## **RE:** Comments on the Draft Bay Delta Conservation Plan and DEIS/DEIR

On behalf of Defenders of Wildlife, the Natural Resources Defense Council, and the Bay Institute, and our combined membership and activists, we are writing to submit comments on the draft Bay Delta Conservation Plan ("Draft Plan") and associated Draft Environmental Impact Report and Draft Environmental Impact Statement ("DEIS/DEIR").

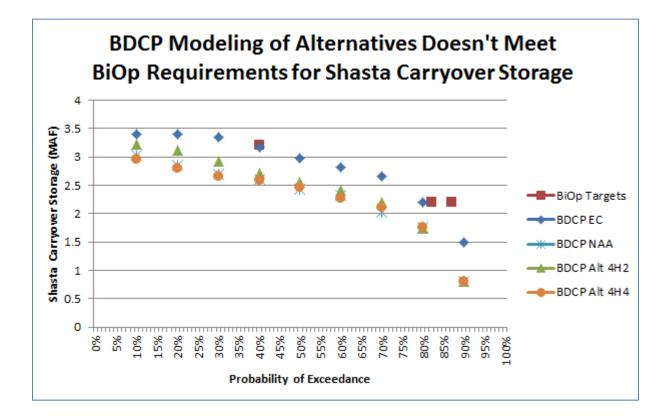
The DEIS/DEIR states that, "If necessary, comparisons of model results against threshold or standard values should be limited to comparisons based on cumulative probability distributions." DEIS/DEIR Appendix 5A, Section C, at C6. Yet the exceedance of a standard should result in probabilities close to zero, and the lack of such output indicates that the models are inaccurate.

intention" of meeting D-1641 standards. This does not seem to be the case in certain dry years such as 2013 and 2014, and the effects of similar relaxations of water quality standards and other environmental requirements in the future are not analyzed or disclosed in the DEIS/DEIR, despite the fact that such changes are reasonably foreseeable. According to the 2014 independent panel review of delta outflow and other stressors, "The average measured Delta outflow during fall 2013 was approximately 2,000 cfs, which failed to meet the Board's minimum outflow requirement of 3,000 to 3,500 cfs for fall months of a critically dry year." DSP Outflows Review Panel Report 2014 at 15. Likely future waivers and relaxations of standards modeled in BDCP are yet another example of how the modeling of BDCP fails to accurately assess likely environmental impacts.
